Record Summary for Board of Adjustments

Record #	Status	Opened Date
BOA-25-000057	In Review	08/26/2025

I am requesting to add a Variance to (encroachment into the side setback 5ft)

**ADDITION TO AN
EXISTING BUILDING**

SITE PLAN

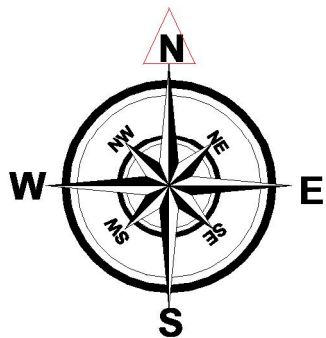
Issues that require Board action: NEEDING APPROVAL FOR SYSB- 5' NOT MET

Description: *ADDITION*
There is a non-permitted structure that encroaches the SYSB entirely. Applicant is proposing to utilize structure as storage space.
ADDITION

Alternative resolutions discussed/offered: *The structure that encroaches the SYSB is currently used for garage space. Unfortunately they're not meeting the 20' distance in the (R) as well as the 5' for the SYSB. Alternative is to use as storage w/ meeting 5' in SYSB.*

Z: R- 7.5(A)
F- 25'
S- 5'
R- 5'
P- 1
HT- 30'
LOT COV.- 45%
